POLICE ACADEMY  
HILLA, IRAQ

**SIGIR PA-05-032**  
**JANUARY 31, 2006**

SUBJECT: Report on Project Assessment of the Police Academy, Hilla, Iraq  
(Report Number SIGIR-PA-05-032)

## Police Academy in Hilla, Iraq

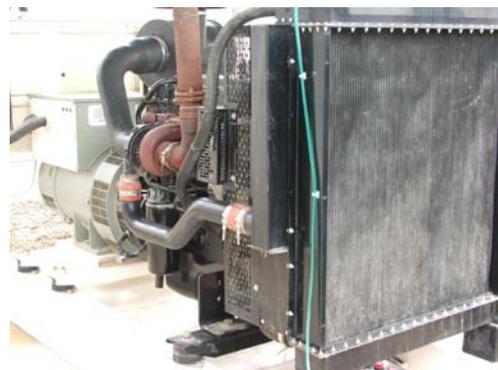
Section 5.15.5 of the SOW required the contractor to provide an electrical power supply and distribution survey on the existing conditions and an electrical power supply and distribution design. A review of the contract files show the contractor provided neither.

Further, Section 5.9 of the SOW required the contractor not to begin construction until the Government's Project Engineer approved the contractor's design. A review of the contract file and discussions with JCC-I/A indicate the Government did not appoint a Project Engineer nor was a project design submitted for the electrical distribution system.

**Site Photo 12. Grinder Pump Basin with Close-up of Pump**

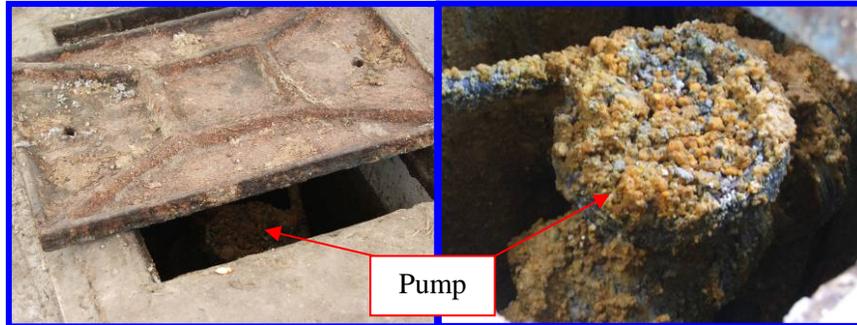
**DABV01-04-M-8070:** The wastewater facility did function as the contract required. The contractor did not resolve the design, capacity, and operation issues. Although, the system was designed to operate with two pumps, only one pump was installed.

The contract originally called for a wastewater lift station with a grinder pump (and a backup pump) capable of transferring effluent 500 linear feet from the camp to the nearest city sanitary sewer manhole; our assessment showed one pump. The wastewater

is not pumped to a city sanitary sewer manhole but it is pumped to wastewater collection tanks on site where it is stored until collected by vacuum trucks. Site Photo 12 shows the grinder pump basin and a close-up of the pump. The pump is entirely encrusted with deleterious material deposits which indicate no preventive maintenance was performed.

**Site Photo 16: 220 KW Generator at Hilla Police Academy**

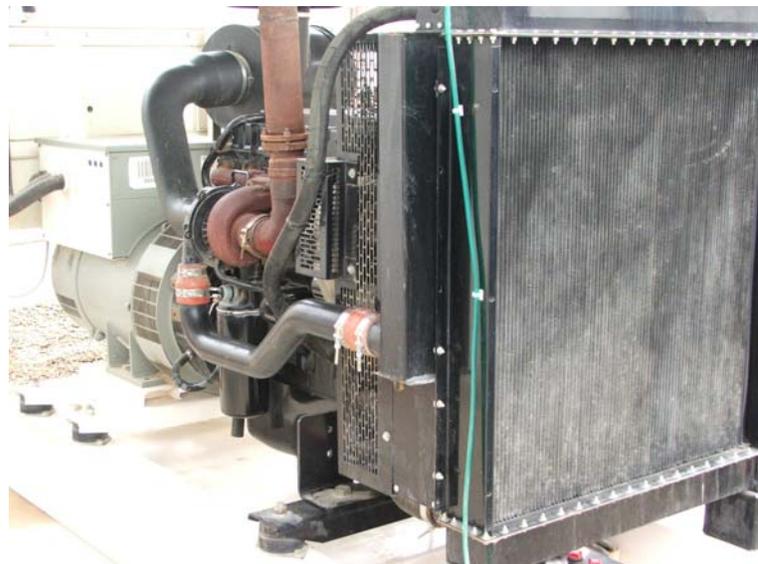
The other generator onsite, shown in Site Photo 16, is rated at 220 kilowatts. While on site, an employee of the current life support contractor, SBIG, started the engines on both generators and let them run for several minutes. However, the generators did not carry any electrical load during the test runs. The police academy currently relies on commercial power as its primary source of electricity, with the generators serving as a backup. At this time, it could not be determined how much of the electrical demand from the police academy could be supported with power supplied solely from the two generators.
